**CHARTER TOWNSHIP OF VAN BUREN
PLANNING COMMISSION AGENDA
Wednesday, July 13th, 2022 – 5:30 PM
Van Buren Township Hall
46425 Tyler Road**

**Subject: VBT-22-006 Meijer / 9701 Belleville; Special Land Use Review #2
Revised Site Plans Dated June 15, 2022**

**Subject: VBT-22-006 Meijer / 9701 Belleville; Site Plan Review #3
Revised Site Plans Dated June 15, 2022**

Meijer Addition & Renovation Site Plan Final Site Plan and Engineering Review

Paving and Grading

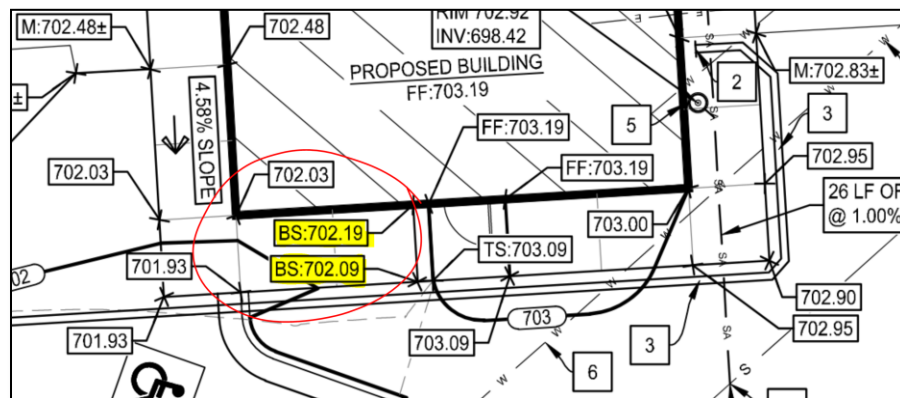
Existing: The plans provided show the existing HMA parking lot and islands are currently configured. Existing topographic survey of the area also indicates the existing layout of the sidewalks, ramps, and parking lot areas.

Proposed: The applicant's plan proposes resurfacing the area in front of the building with either an HMA overlay or a full concrete reconstruction, as well as a new pavement (concrete) pad for the drive-thru area. Other paving modifications include the areas around the new islands, the new pharmacy drive-thru, and the gas station parking lot reconfiguration due to the building expansion. There is no indication of any other repair or maintenance to the site pavement, except that impacted by the construction.

1. Applicant to verify the grades around the gas station building. Below shows a snippet where there is a 1.0 ft grade difference:

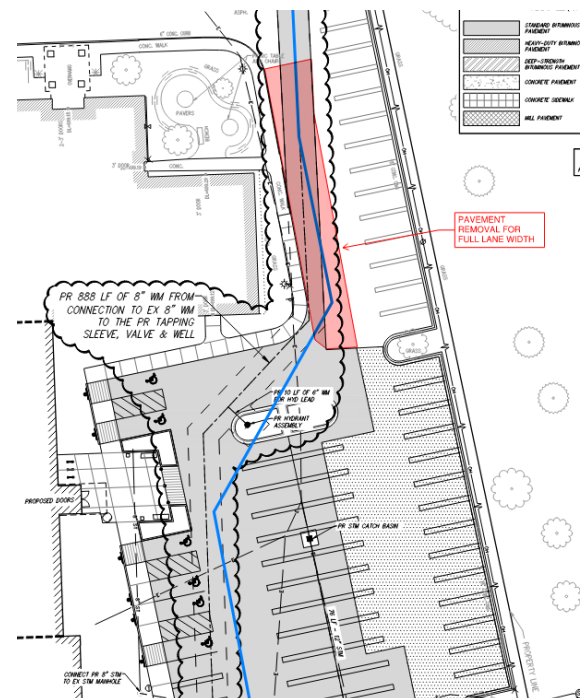
1. The new water main alignment has eliminated many of the unnecessary bends within the loop, however, has now created some alignments that may cause issues with future maintenance and lends to some awkward offsets and unfavorable pavement replacement. The previous straight-line alignment of the water main was acceptable (and desirable) however the excess bends were the problem. A hybrid of the two designs, similar to the blue line (drawing to the right) should be considered. The applicant shall explore a configuration that limits the number of required fittings and places the proposed water main locations are easily accessible for future repair and maintenance, which also limits the impact to pedestrian access (sidewalk repair).

2. Please also see the red outline for limits of pavement replacement to be sure no slivers of pavement remain. Uniform pavement repair/replacement shall be done when possible (See General Note No. 4).

Response: *Ongoing conversation with Fishbeck have occurred to provide a configuration that limits the number of required fittings and places the proposed watermain locations are easily accessible for future repair and maintenance, which also limits the impact to pedestrian access.*

Response: *Plans have been revised per limits of pavement replacement to be sure no slivers of pavement remain.*

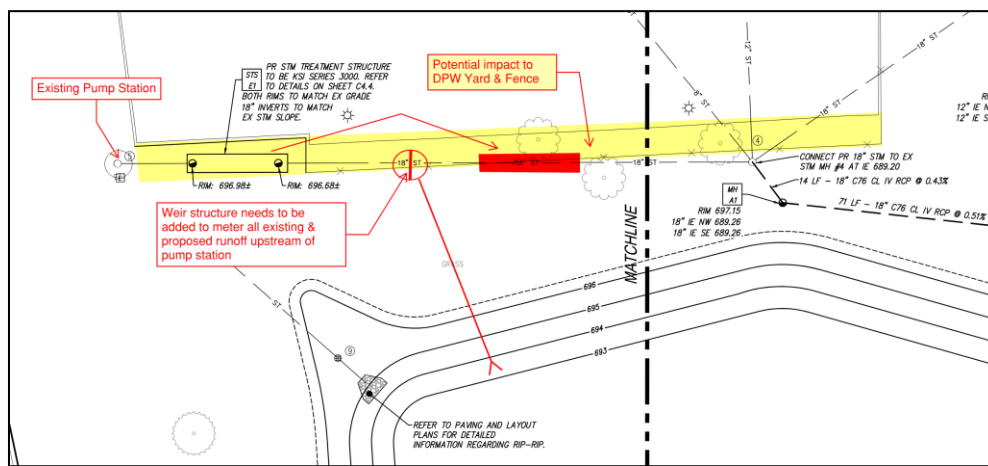
Existing: The existing Township Hall site collects runoff via a combination of spillways, culverts, and enclosed sewers. The system eventually outlets to an existing lift station.

Proposed: The applicant's plan is proposing to capture stormwater runoff via a system of inlets and an enclosed storm sewer system. The proposed system is designed to connect to the existing storm sewer system upstream from the proposed mechanical treatment structure. The plans currently show no weir structure to meter the flow of runoff into the existing pump station.

Township Discussion: Prior to submittal of the updated plans, the Township and the applicant have had several conversations about consolidating the overall stormwater management for both the proposed and existing system. Information on the existing pump station did not determine a metered value that could be used to determine if runoff was being detained the proper amount of time, thus it was determined that the entire contributing system would need to be accounted for and detained per Township Standards. The applicant would be responsible for detaining all flow upstream of the pump station for the required time, per the Township standards. The assumption was made that the existing swale/detention ponds between the soccer fields were functional and the flow from anything south of the splash pad would not be considered. Based on this criteria, the applicant has proposed a single, larger pond to accommodate all the incoming flow. The pond will be a dry pond, which is acceptable by the Township.
